R001 - DRAFT SEQUENCE - NOT INSTALLATION APPROVAL

Depth and sealing / review correction

02 / Check plumbing and factory adjustment

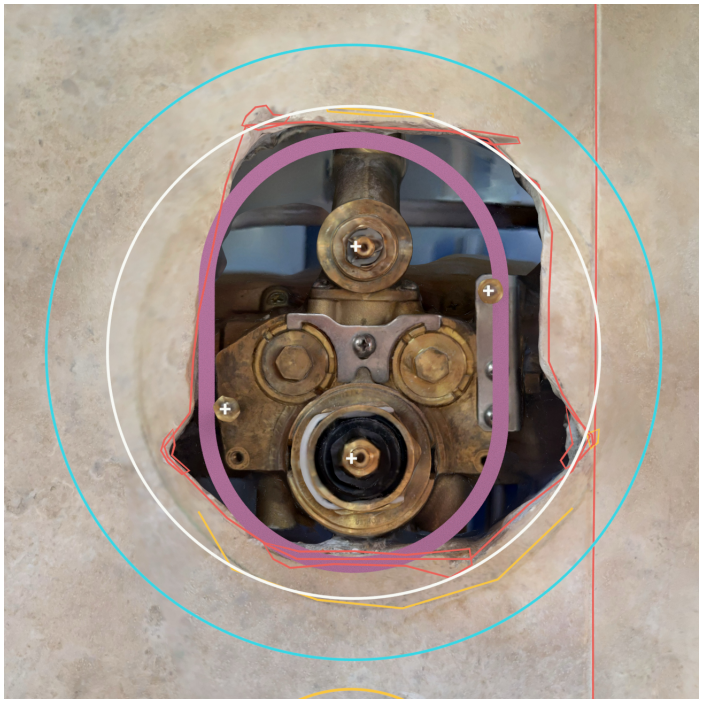
Trace reported rear stud contact with wood; verify valve rough-in depth and identify the stem adapters separately. Check available adjustment, final seating and supply/valve leakage before selecting a repair.

Do not shorten studs, force trim, or loosen pressure-containing parts for a homeowner measurement. No valve relocation target is approved.

Stud rear travel and engagement, Check 10 tip identity/depths, plaster-guard or axis-datum check, and correct adapter/handle seating recorded.

05 / Install only the released material detail

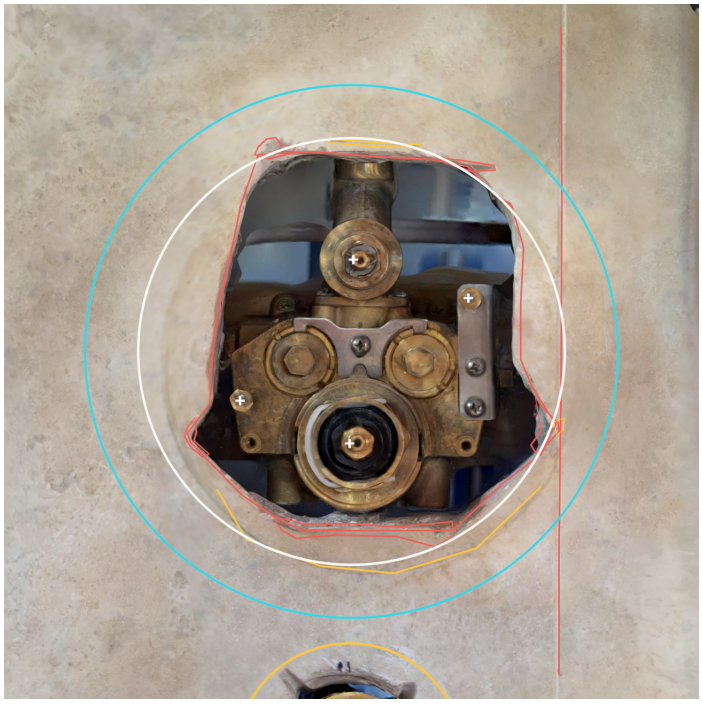
The current seated-cover trial has solid intersections and is rejected. No selected mortar, backing, sealant, finish or cure schedule exists. Do not install from this draft.

Control depth / diagnostic follow-up

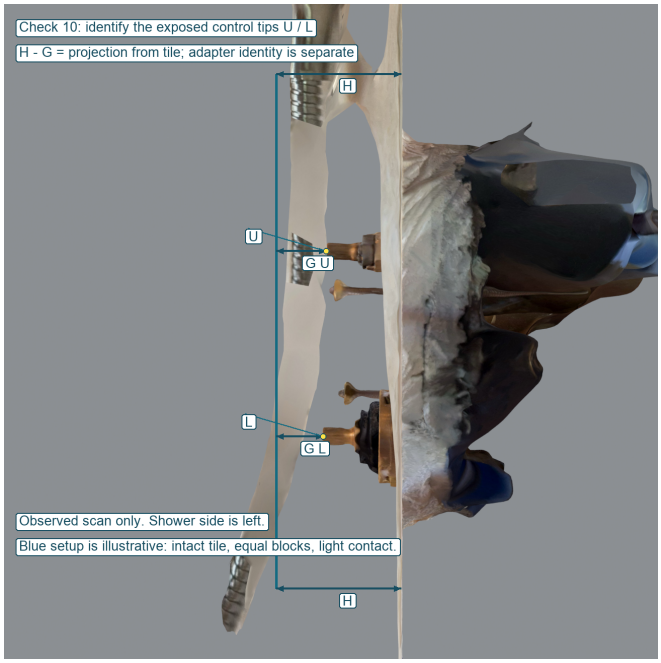
The user confirms excessive stud projection and reports rear bolt contact with wood. Trim studs thread into the valve; they do not need wood anchorage. Identify the same rear fasteners, framing/blocking and usable travel before selecting a remedy.

K-2973-KS specification p3: the labeled upper bare-tip and finished-wall dimensions imply a nominal upper-tip interval -6.3 to 27.0 mm from tile. Current comparison: 32.0 mm (conditional scan tip; identity and physical scale unverified). This is outside nominal interval if same bare tip. It is not a valve-relocation target.

Check 10 identifies the as-found tips/adapters and records block height H and both underside-to-tip gaps. H - G gives signed projection. The installer separately checks the plaster guard or documented axis datum. The 7/16-inch trim-stud limit does not apply to control stems.

Correct adapter and screw lengths must permit handle engagement and full cover/bonnet seating. An added backing plate changes that relationship again. Internal valve seals contain supply water; improper trim seating concerns external shower-water entry. Test these separately after the complete assembly is resolved.
